OFFICIAL NOTICE OF DECISION

Project # PR-2025-011387
SI-2025-00040 – Site Plan – EPC

Consensus Planning, Inc., agent for Pulte Group, requests a Site Plan – EPC for an approximately 60 acre portion of Tract N-1, Correction Plat of Tracts N-1 & N-2, Watershed Subdivision (AREPL of Tract N Watershed Subdivision), located at 9601 Tierra Pintada Blvd. NW, at the NW corner of Arroyo Vista Blvd. NW and Tierra Pintada Blvd. NW, approximately 110 acres. (J-7) (J-8)

**RE: APS Tres Volcanes - Entitlement Authorization for Tract N-1-B Watershed
Subdivision**

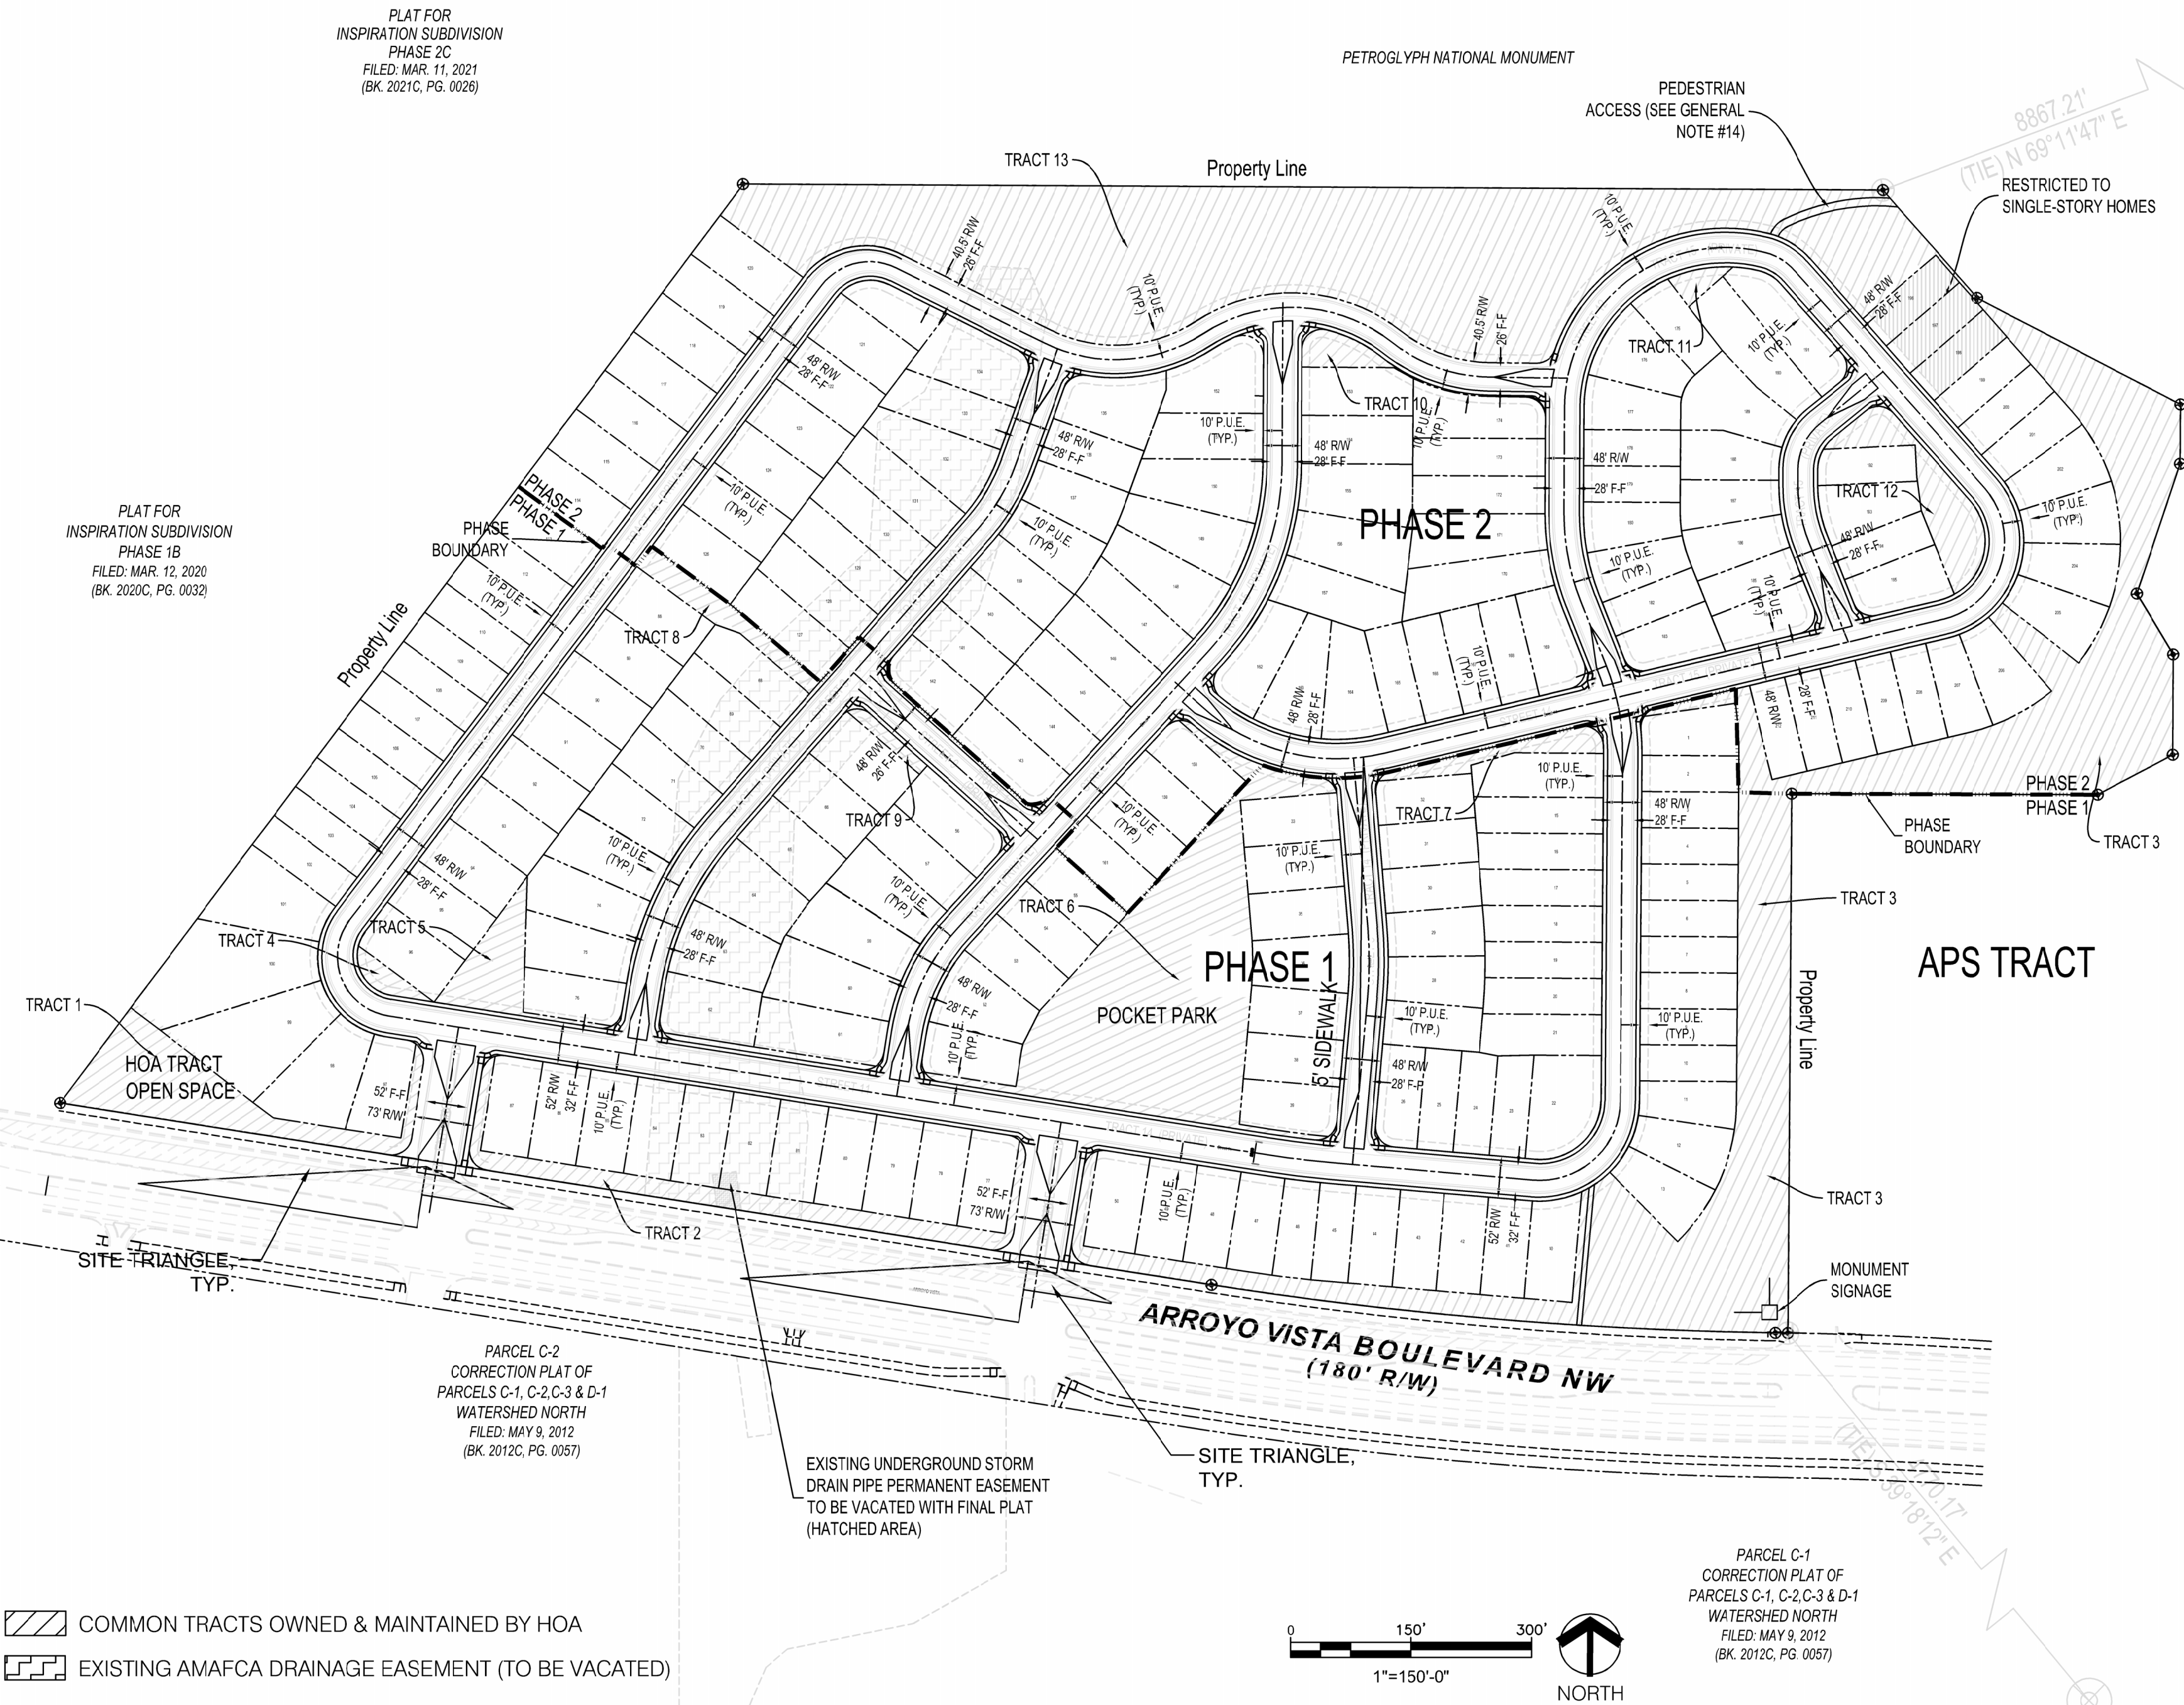
5. The proposed future waivers to the IDO and DPM requirements should be approved prior to final signoff of the Site Plan-EPC.
6. Landscape Plan:
 - A. An updated landscape plan shall be provided which depicts one street tree per lot or a general note shall be provided which states that this requirement will be met.

- B. The site plan references a pocket park and the landscape plan references a neighborhood park. The sheets shall be updated to match.

- A. A detail of the fencing adjacent to the open space requested by the National Park Service and the wall adjacent to the ABQ Public School shall be provided that notes: perimeter walls adjacent to the open space and APS to be constructed with a lower CMU portion and view fencing on top. The applicant shall work with the National Parks Service on finalizing fence design details along the Monument boundary.

- B. A solid wall with no view fencing along Arroyo Vista Blvd NW shall also be noted.
 - C. For the perimeter wall, a note shall be added that matches the color pallet of the entry gate wall: “overall color palette to be bronze, tan, beige and dark brown with pops of blue and gold accents.”

8. A note shall be added to the Site Plan that references Pedestrian walkways and Materials to Alert Motorists, See Table 5-3-1 and IDO §14-16-5-3(D)(3)(c).

9. The Site Vicinity Map shall be updated on the site plan to include the full 110-acre site.
10. The Site Plan shall comply with the General Regulations of the IDO and all other applicable design regulations, except as specifically approved by the EPC.

CONCEPTUAL GRADING & DRAINAGE PLAN

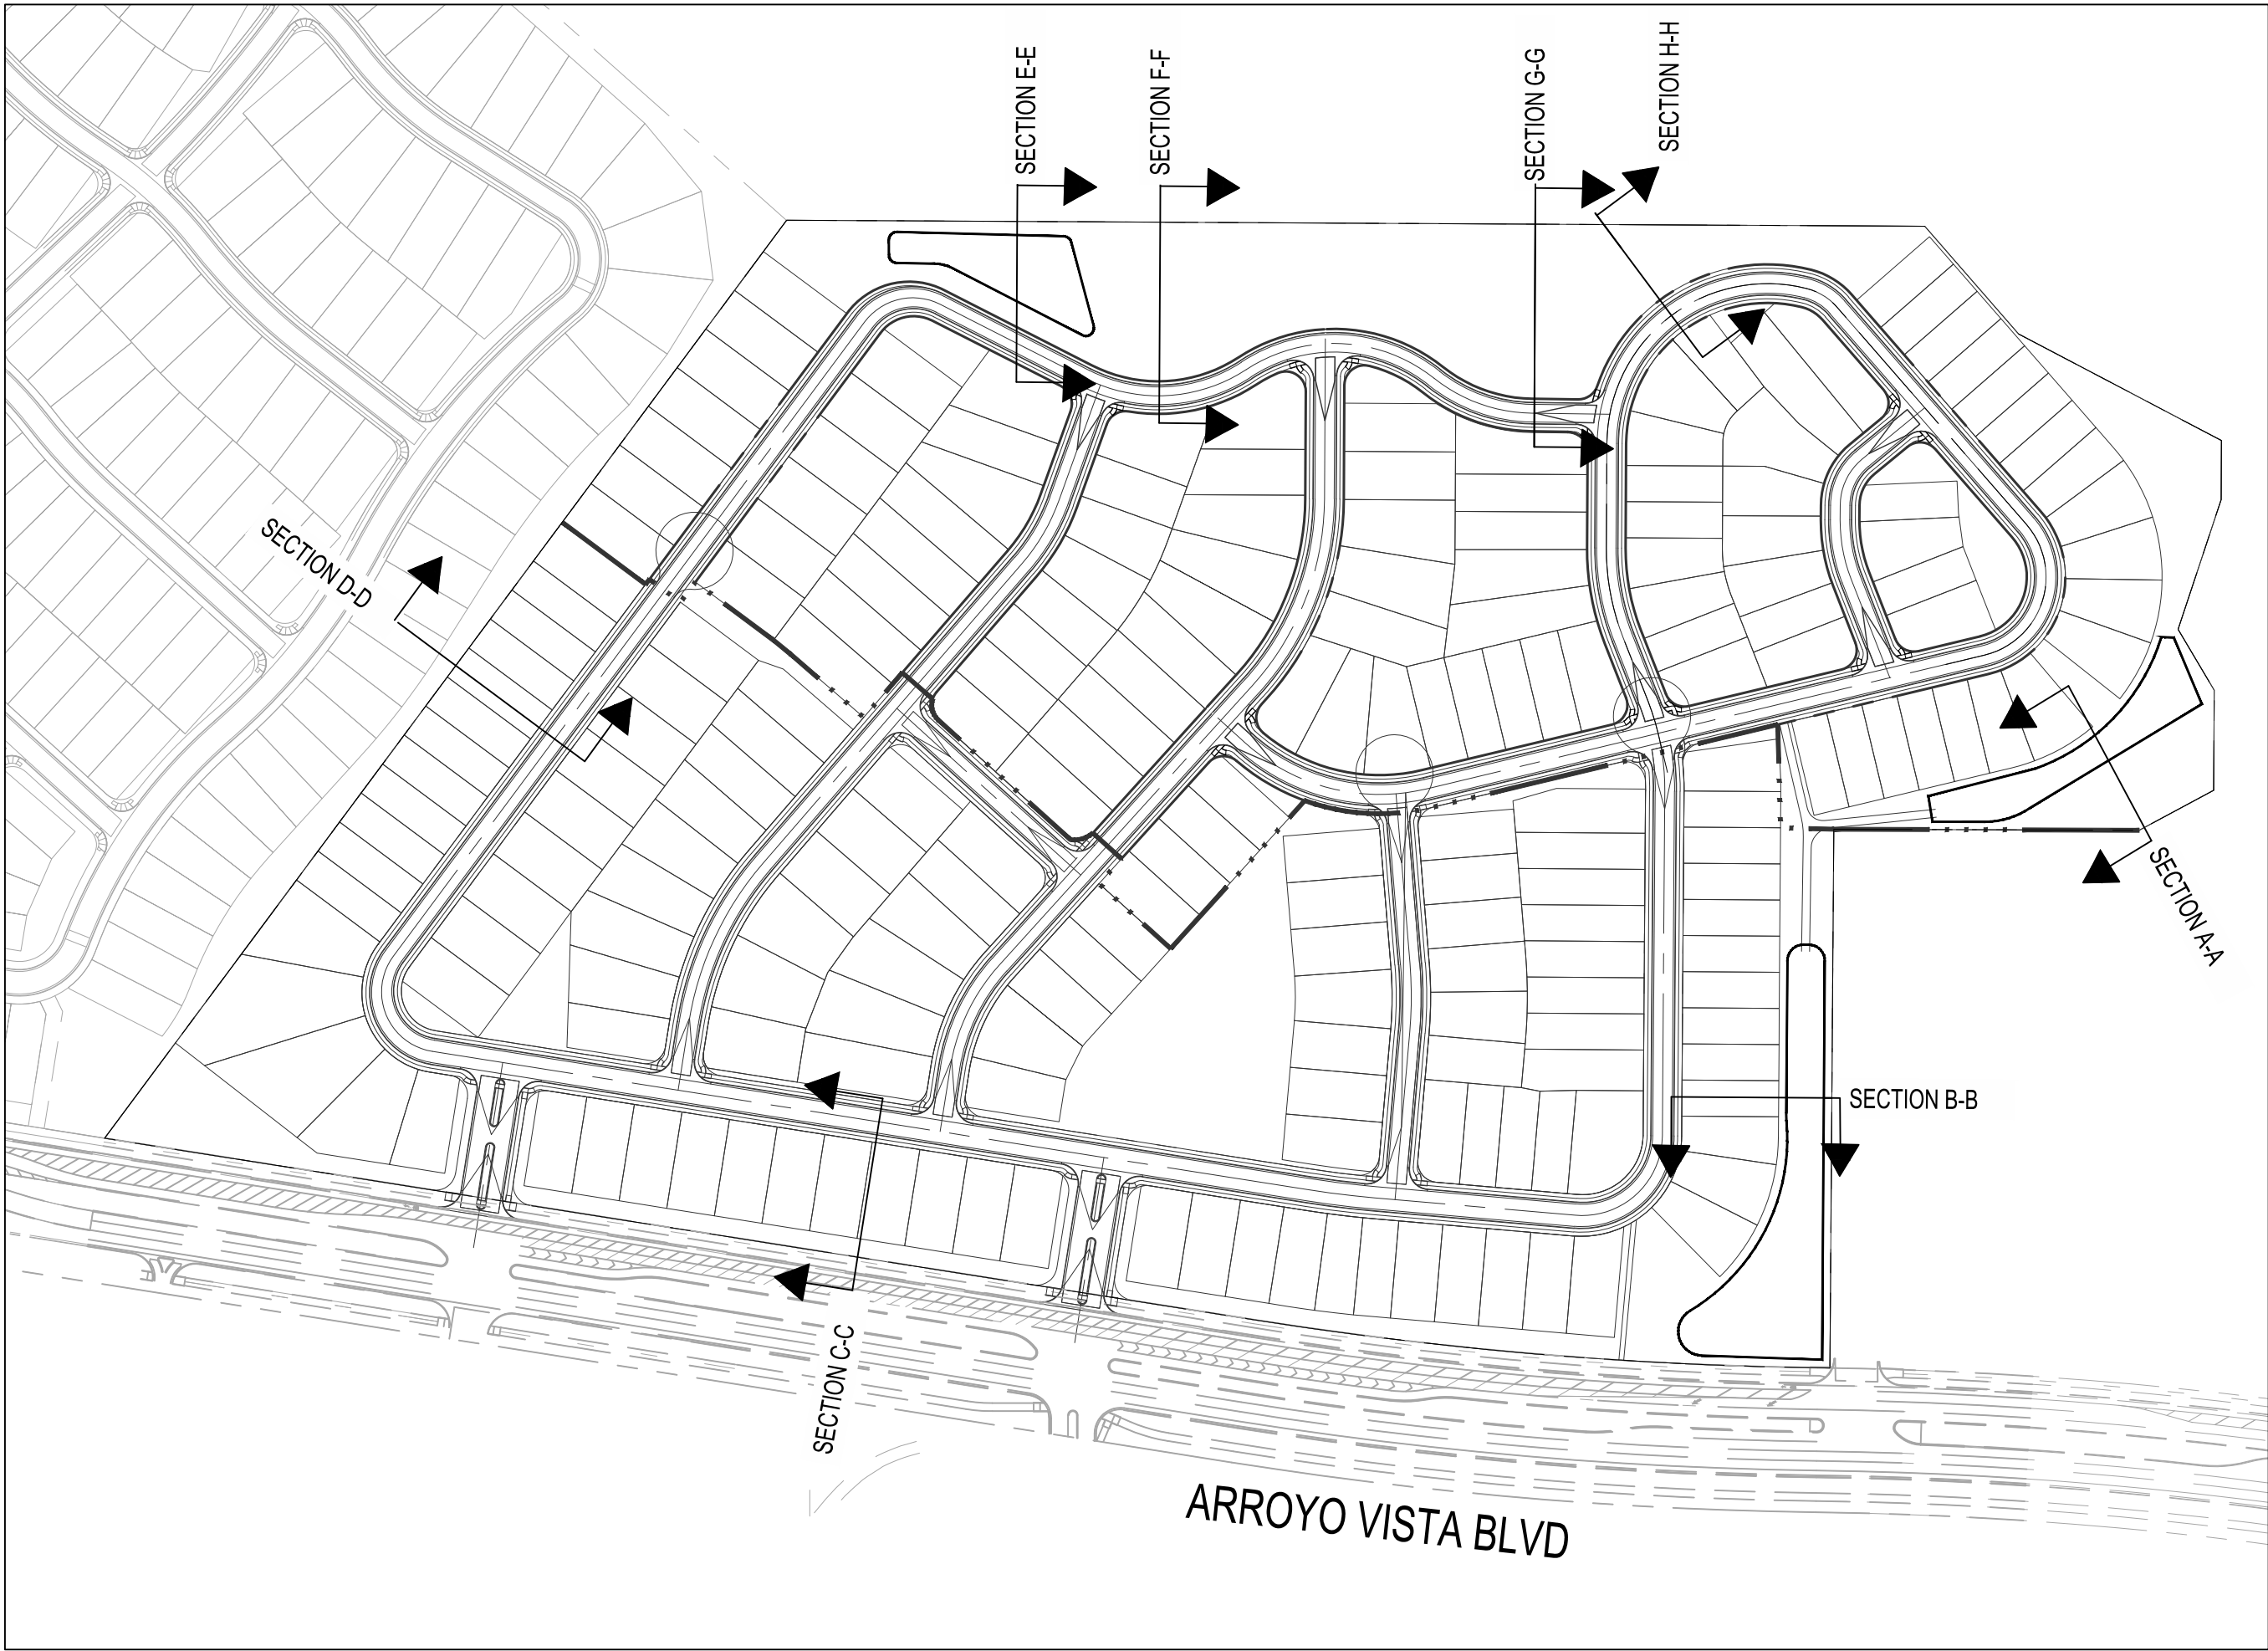
Based upon the information provided in your submittal received 3/3/2025, the Conceptual Grading & Drainage Plan is preliminarily approved for actions by the EPC, DHO and/or DFT for Site Plan and for Plating actions.

- Provide more detailed design as needed in order to obtain the City Hydrology and AMAFCA's approval.
